This page is devoted to notes on errors in layout that need to be fixed in future revisions

| Title <b>Dwarf Core</b> |                                      |  |                          | Number <b>1002250</b> |                                |
| Size<br><b>A</b>        | Engineer <b>Scott Jensen</b>         |  | Layout <b>Jose Rosal</b> |                       | Filename <b>Core_REV_2_0_0</b> |

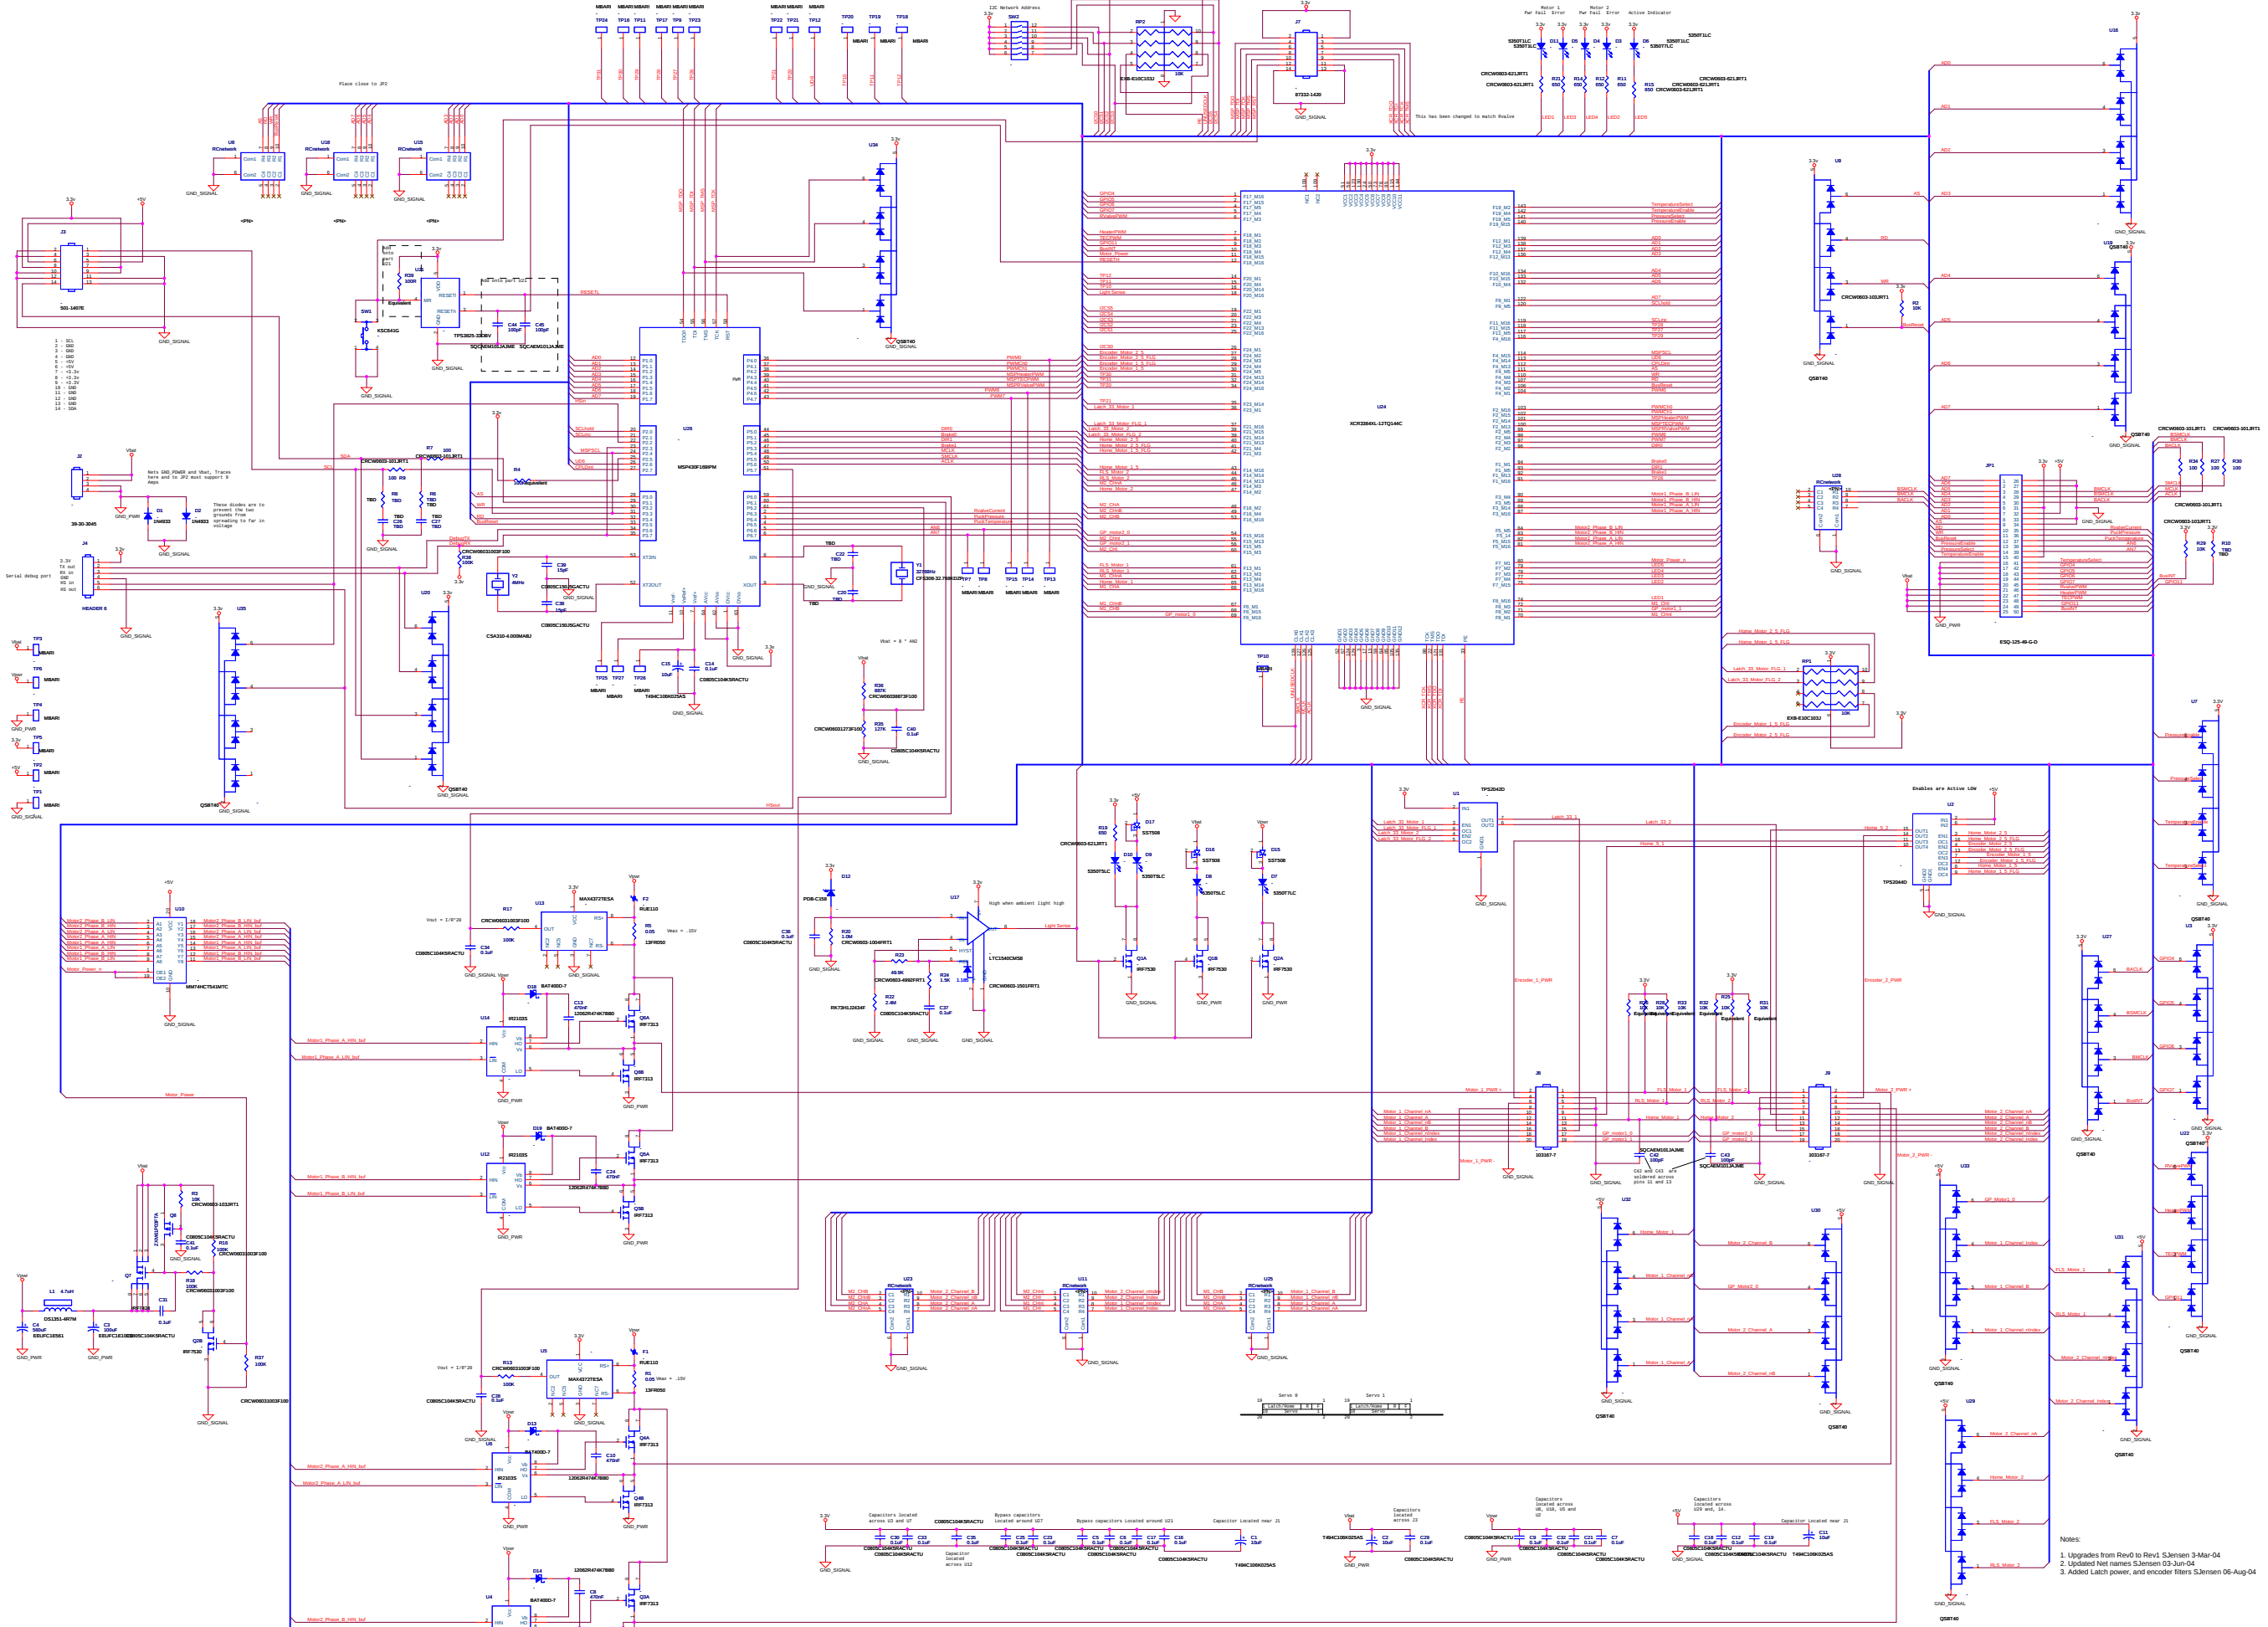
U32 - reset generator, footprint has been inadvertantly changed to a resistor pack. Need to be changed back to a SOT package, Refer to REV 0\_0\_2.
